<b>Well Name:</b> ANGEL PEAK 1	<b>Well Location:</b> T27N / R10W / SEC 1 / NESE / 36.602405 / -107.841722	<b>County or Parish/State:</b> SAN JUAN / NM
<b>Well Number:</b> 20S	<b>Type of Well:</b> OTHER	<b>Allottee or Tribe Name:</b>
<b>Lease Number:</b> NMSF077384	<b>Unit or CA Name:</b>	<b>Unit or CA Number:</b>
<b>US Well Number:</b> 3004532431	<b>Operator:</b> HILCORP ENERGY COMPANY

**Type of Submission:** Subsequent Report

**Type of Action:** Plug and Abandonment

**ANGEL PEAK 1 20S****30.045.32431****PLUG AND ABANDONMENT**

## Current Schematic - Version 3

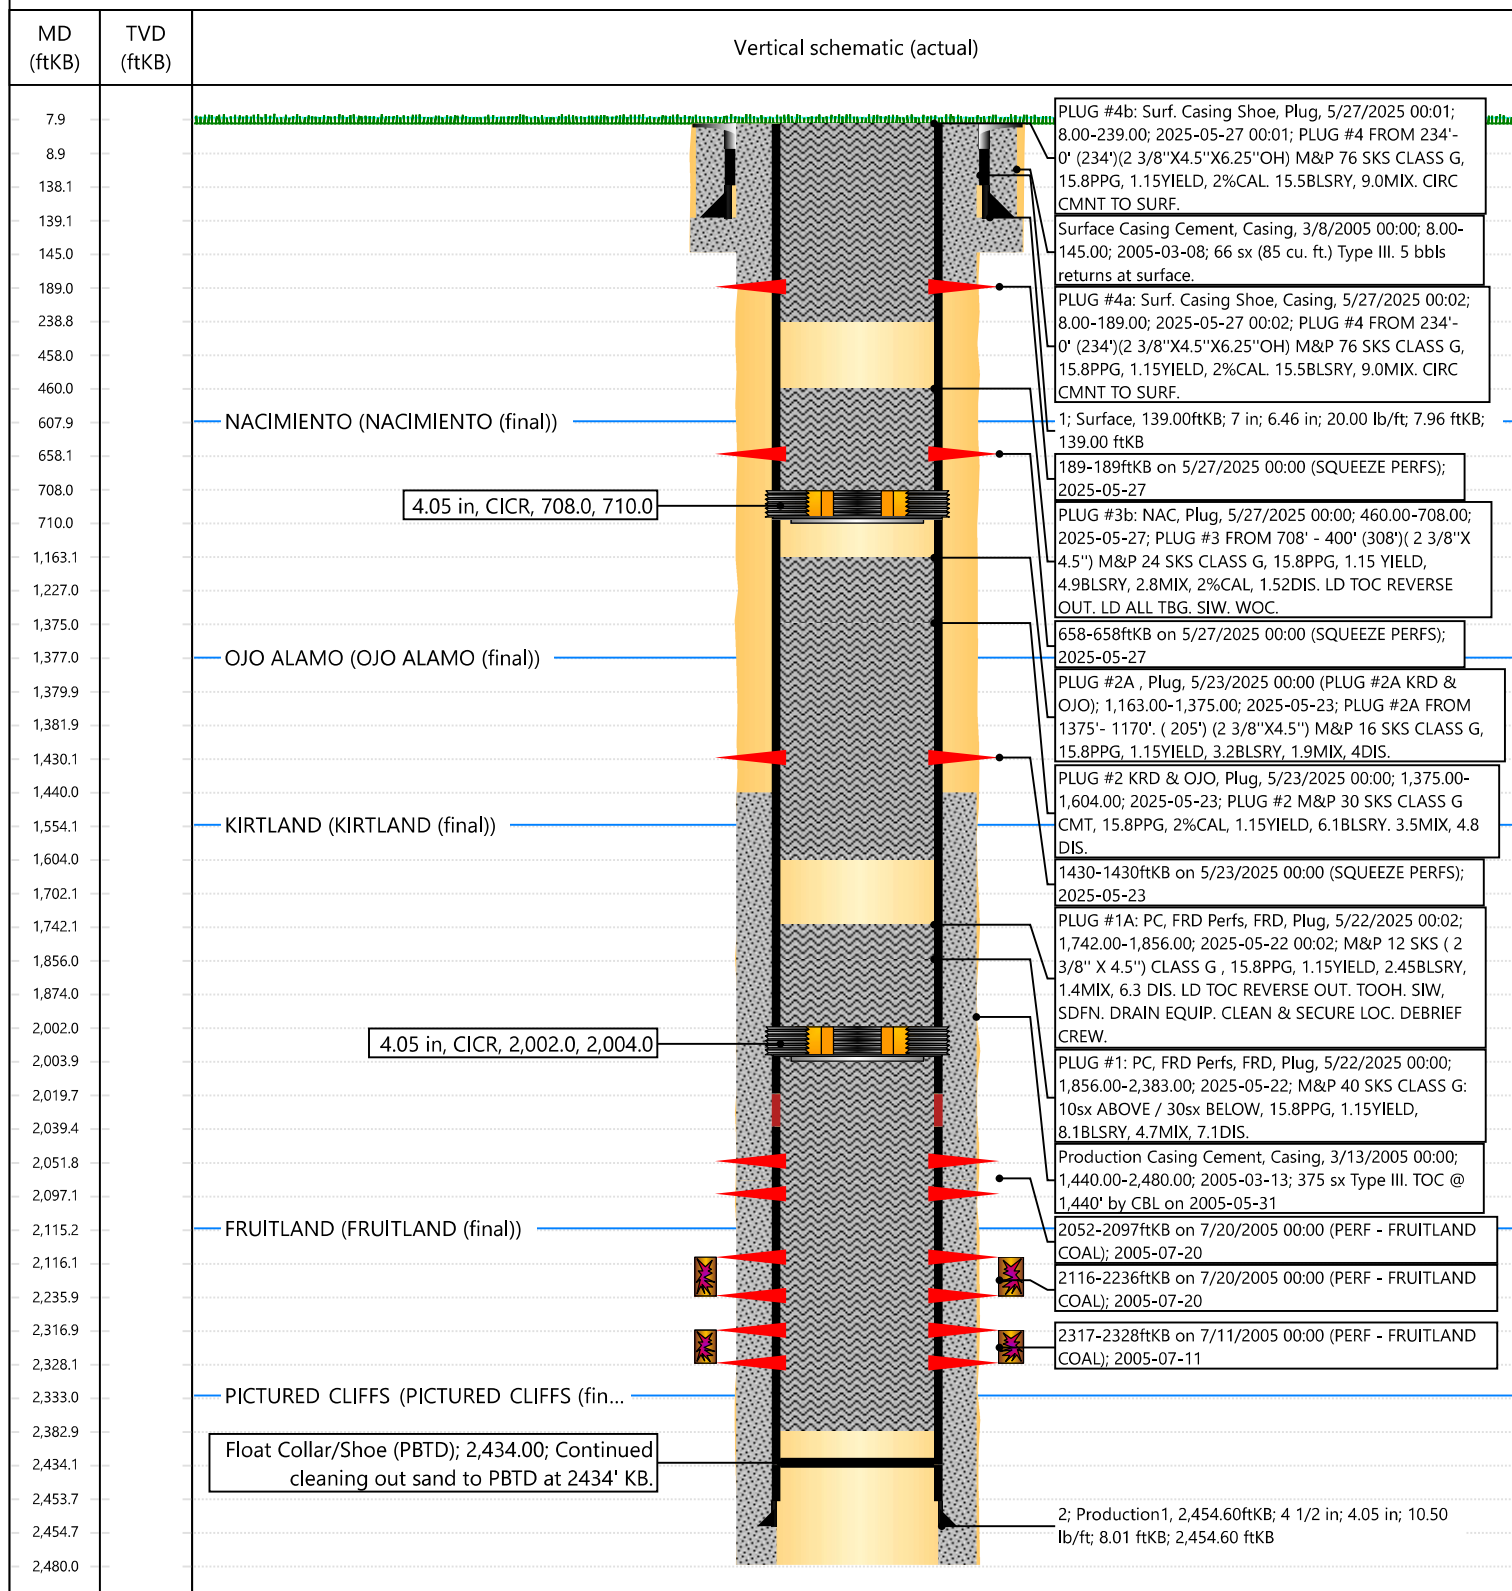
- I agree with the BLM pick of 1,440' for TOC and have updated the schematic to reflect that. I don't think the Well Completion report of 300' is correct.
- I split out the Kirtland and Ojo to be it's own plug, and am proposing perforating 10' above TOC, and pumping the equivalent cement volume to TOC on the outside, and to 50' below the Kirtland for the inside plug.

- There seems to be some inconsistencies in the perf depths between the Well Completions Report and the Daily Job logs, however, I added the interval from 2052' – 2097' and updated the CIBP placement and cement volumes to account for it in case they are there.
